ASR9

SSM-ASR9-019

**System
Support
Modification**

RECEIVER PROTECTOR REPLACEMENT

WAVEGUIDE FLANGE TORQUING SEQUENCE

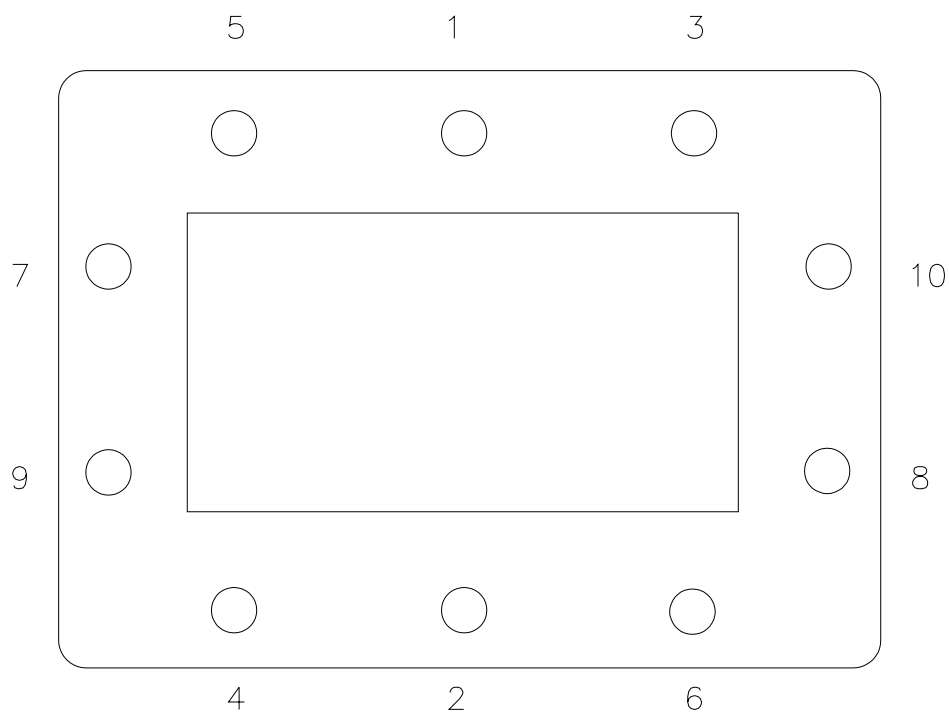
WAVEGUIDE FLANGE BOLTS TO BE TORQUED
IN 4 STAGES IN THE SEQUENCE SHOWN:
25 INCH-LBS.
50 INCH-LBS.
70 INCH-LBS.
AFTER 20 MIN. RETORQUE TO 70 ± 10 INCH-LBS

ASSEMBLY DETAIL (SHEET 1)

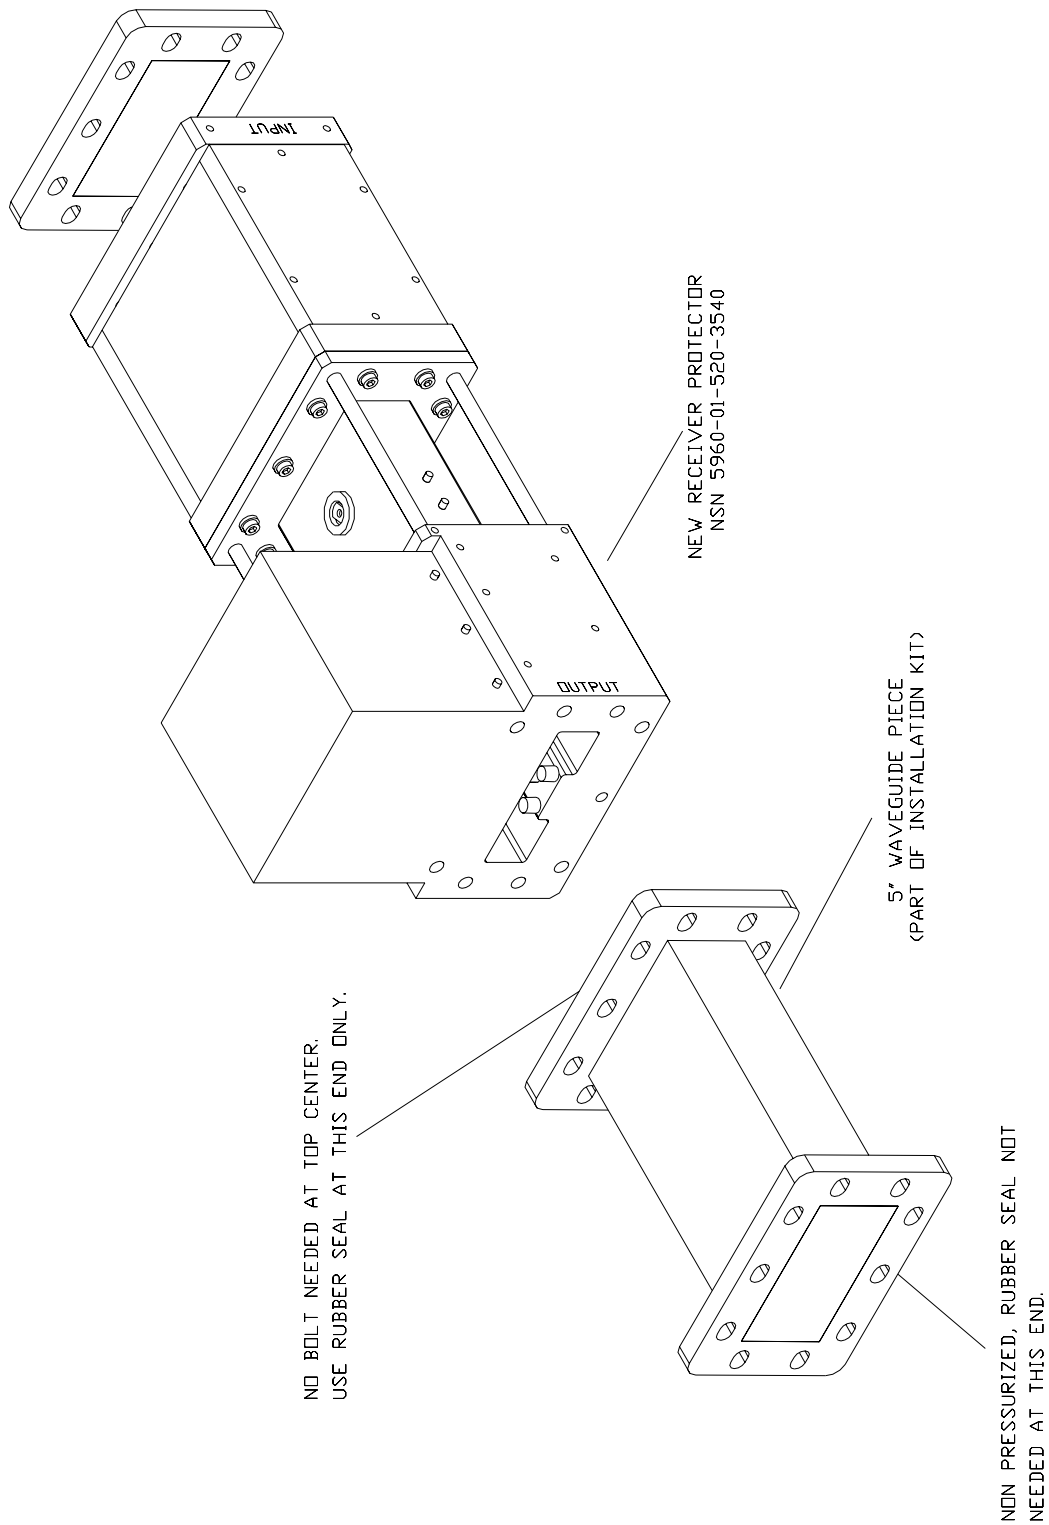
a. Assemble the 4 new replacement sections prior to the arranged downtime, using ¼ x 28x3/4" bolts, flat washers, lock washers and rubber gasket from installation kit. Assemble the new Receiver Protector output end to the 5" straight waveguide as shown on Page 5 of Appendix 2. Follow the waveguide flange bolt torquing sequence requirements outlined in TI 6310.24, paragraph 7.4.1.2 and/or Page 4 of Appendix 2.

ASSEMBLY DETAIL (SHEET 2)

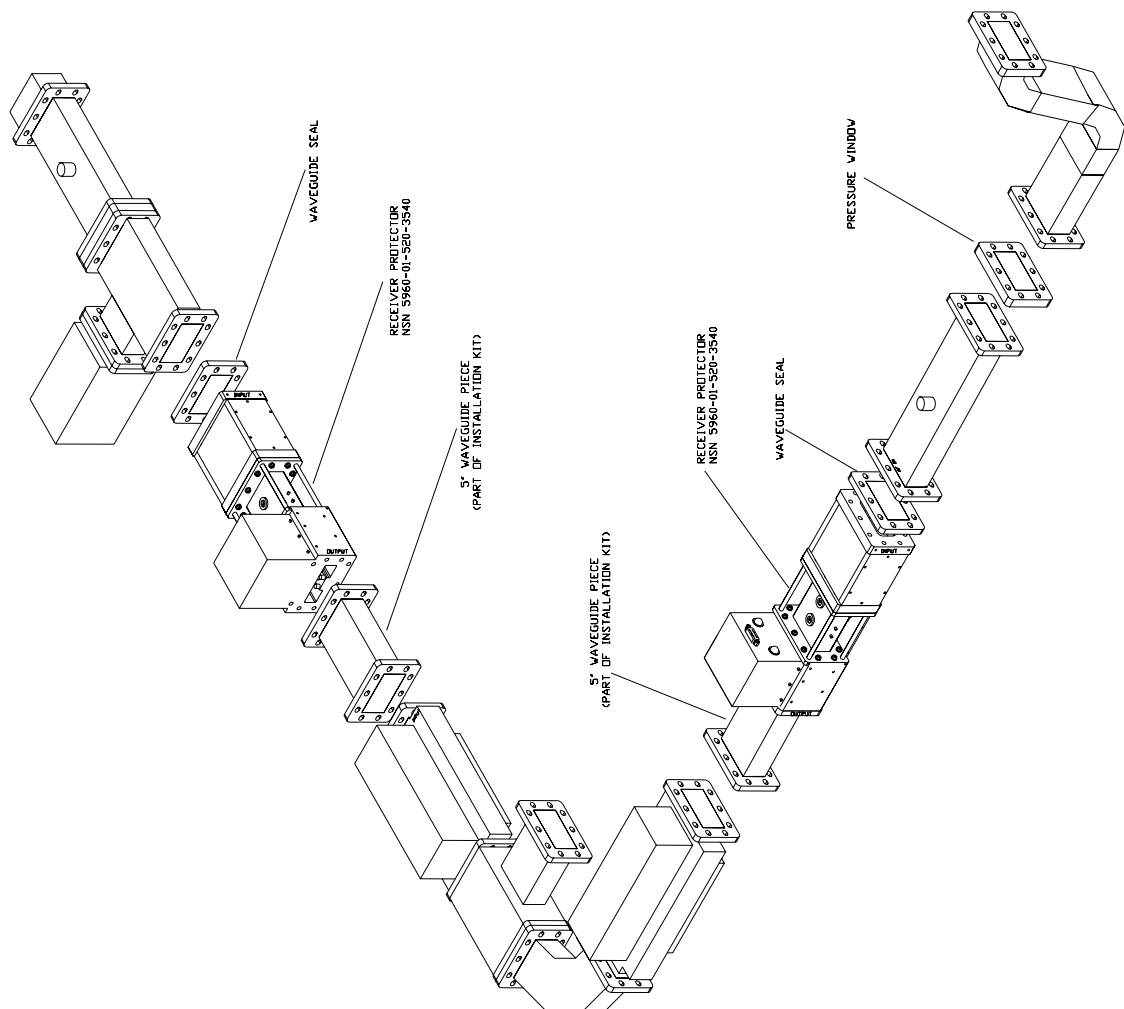
(5) Using bolts, flat washers, lock washers and gasket attach the pre-assembled Receiver Protector section to the ASR9 waveguide structure as shown in Page 6 of Appendix 2. Follow the waveguide flange bolt torquing sequence requirements outlined in TI 6310.24, paragraph 7.4.1.2 and/or page 4 of Appendix 2.

(7) Assemble RF IN end of high beam directional coupler DC2 (DC1) to gasket then the INPUT end of pre-assembled Receiver Protector section. Using bolts, flat washers, lock washers attach the rubber gasket, the above section, Pressure Window to the ASR9 waveguide structure as shown in page 6 of Appendix 2. Follow the waveguide flange bolt torquing sequence requirements outlined in TI 6310.24, paragraph 7.4.1.2 and/or page 4 of Appendix 2.

NOTE: Orientate the RF IN of high beam directional coupler DC2 (DC1) to INPUT of Receiver Protector. The new location of the pressure window is between flexguide and directional coupler. The new location of the gasket is between Receiver Protector and directional coupler.

FIGURE 11-16. WAVEGUIDE PRESSURIZATION SYSTEM (SHEET 2-END)

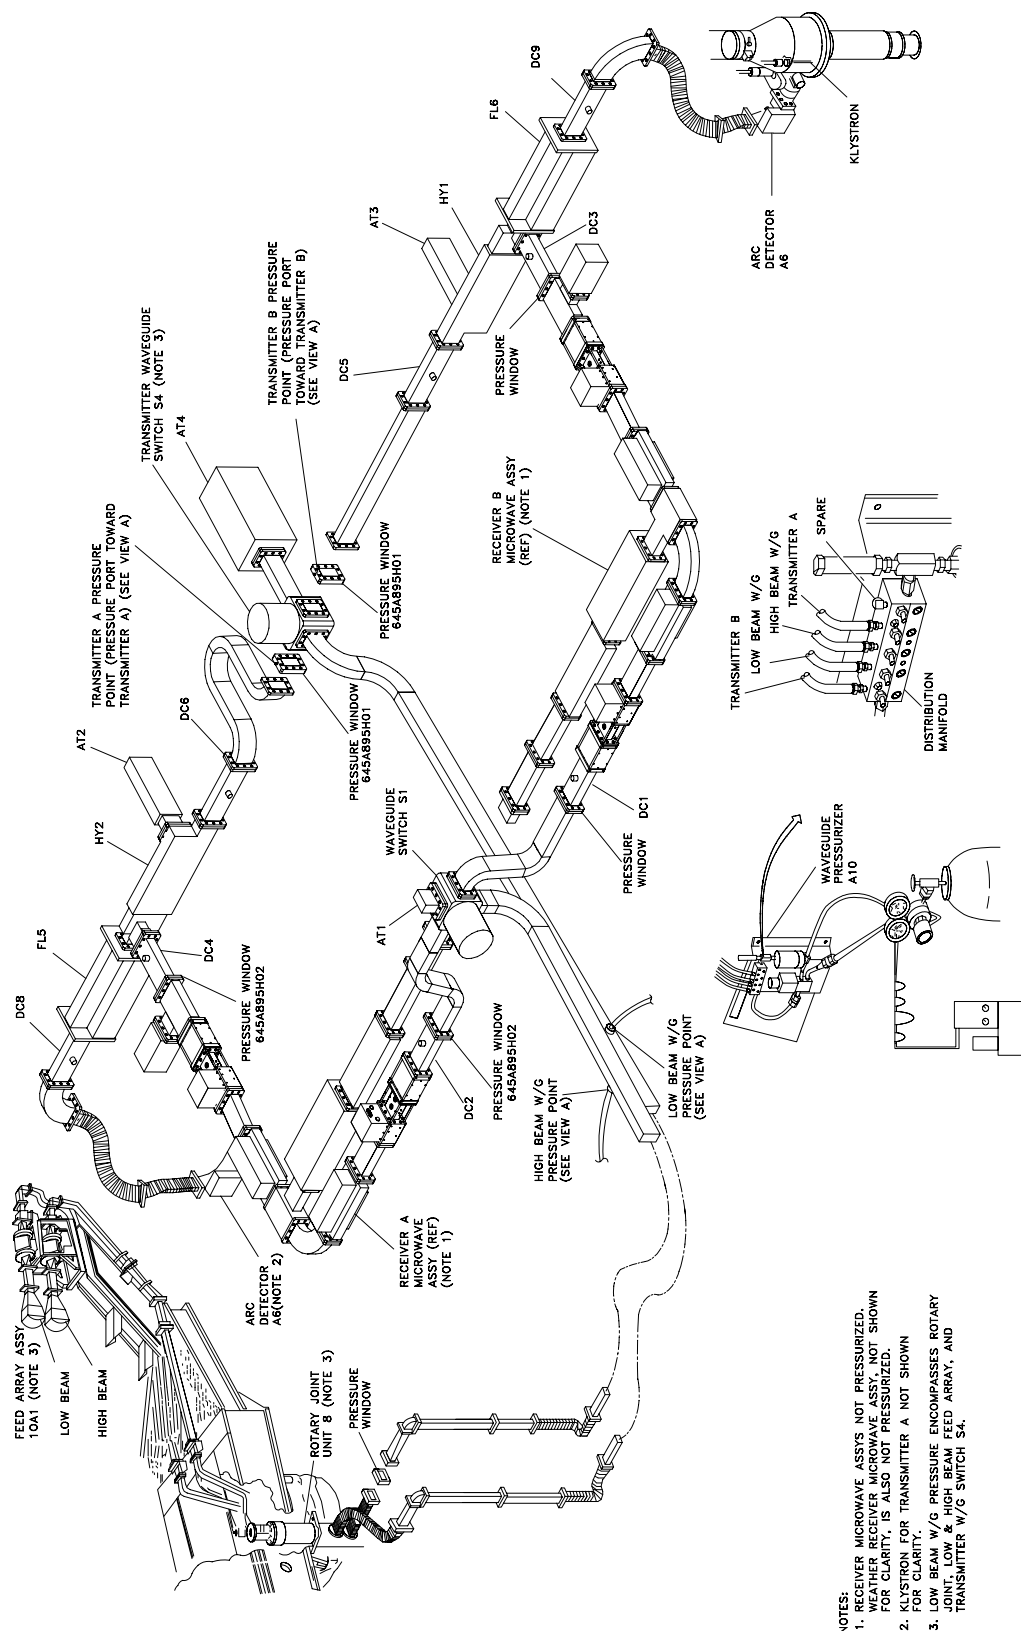
(3) Refer to TI 6310.24 Fig. 11-16, sheet 2 of 2. First turn OFF the pressure by closing only the Standby Transmitter channel and High Beam Waveguide valves located on the waveguide pressurization distribution manifold. Then bleed the air from those sections using the valve core in the adjacent pressure/bleed valve while observing the manifold pressure gauge for any sign of a drop in pressure.
